Part Name: Skidtube with Standard Wearplates Fits LH or RH

DART SERVICE INSTRUCTION

TO AMEND INSTALLATION INSTRUCTIONS IIN-D117-762 REV. E AND
INSTRUCTIONS FOR CONTINUED AIRWORTHINESS ICA-D117-762 REV. 4

A	NEW ISSUE	RF	17.01.09
REV.	DESCRIPTION	BY	DATE
DESIGN	RF	DART AEROSPACE, LTD EUGENE, OR	
DRAWN	RF		
CHECKED	WK	DRAWING NO.	REV.A
MFG. APPR.	N/A	DSI 9771	SHEET 1 OF 2
APPROVED	HS	TITLE	SCALE
DE APPR.		GH L UPGRADE KIT	NTS
DATE	17.01.09	COPYRIGHT © 2017 BY DART AEROSPACE USA, INC THIS DOCUMENT IS PRIVATE AND CONFIDENTIAL AND IS SUPPLIED ON THE EXPRESS CONDITION THAT IT IS NOT TO BE USED FOR ANY PURPOSE OR COPIED OR COMMUNICATED TO ANY OTHER PERSON WITHOUT WRITTEN PERMISSION FROM DART AEROSPACE, LTD.

FIGURE 1 - GHL UPGRADE INSTALLATION

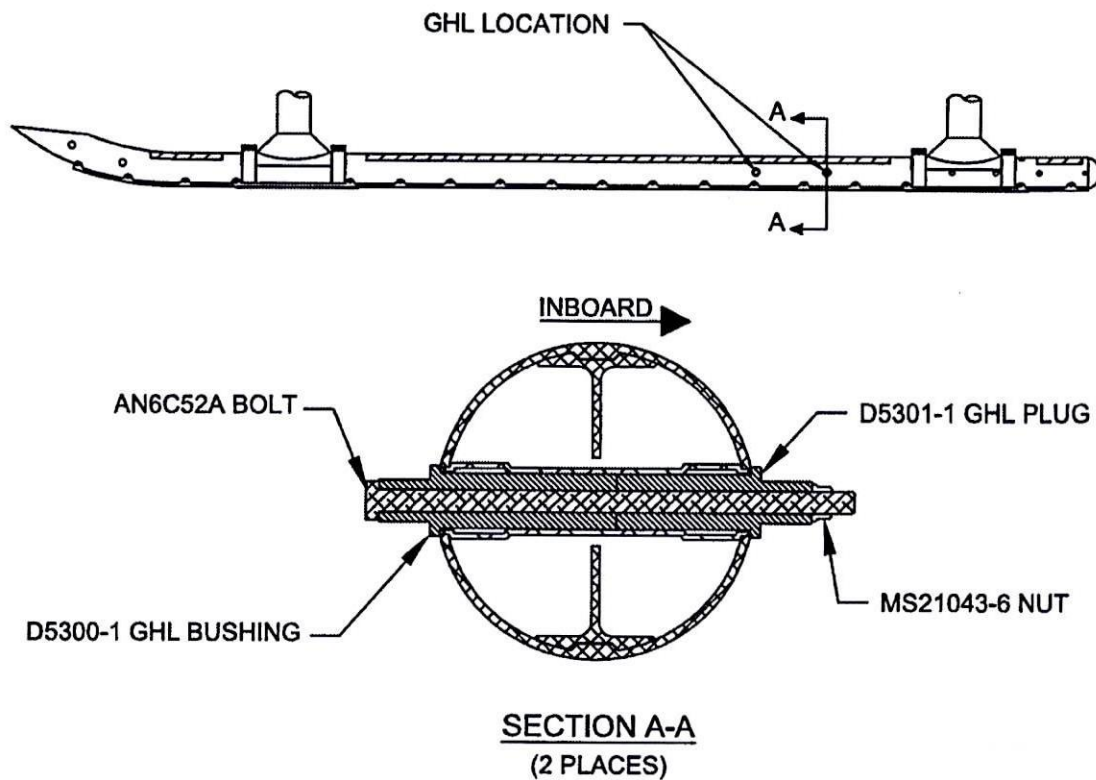
The purpose of this Dart Service Instruction (DSI) is to replace the ground handling lugs (D3864-1 Bushings, AN6C51A Bolts and MS21043-6 Nuts) on the D117-762-XXX Skidtubes with a structurally superior lug design (D5300-1 Bushings, D5301-1 Plugs, AN6C52A Bolts, MS21043-6 Nuts) as shown in Figure 1. The new hardware will be included in D117-762-011 @ CHG 004 and subsequent.

- 2.1 Loosely install (qty 2) D5300-1 GH L Bushing & (qty 2) D5301-1 GH L Plug wet with Proseal 890 or MIL-S-8802 Class B2 Sealant in location shown in Figure 1.
- 2.2 Install (qty 2) AN6C52A Bolts and (qty 2) MS21043-6 Nuts in accordance with Figure 1. Clean up squeezed out Proseal and apply fillet seal around D5300-1 & D5301-1.
- 2.3 Torque AN6C52A Bolts 160 - 190 in-lbs (18.1 - 21.5 N-m).

ITEM	QTY -011	PART NUMBER	DESCRIPTION
	X	D117-762-011	SKIDTUBE INSTALLATION
50	2	AN6C52A	BOLT
51A	2	D5300-1	GH L BUSHING
51B	2	D5301-1	GH L PLUG
52	2	MS21043-6	NUT

ITEM	QTY -011	PART NUMBER	DESCRIPTION
	X	D117-762-011	SKIDTUBE INSTALLATION
50	2	AN6C51A	BOLT
51	4	D3864-1	BUSHING
52	2	MS21043-6	NUT
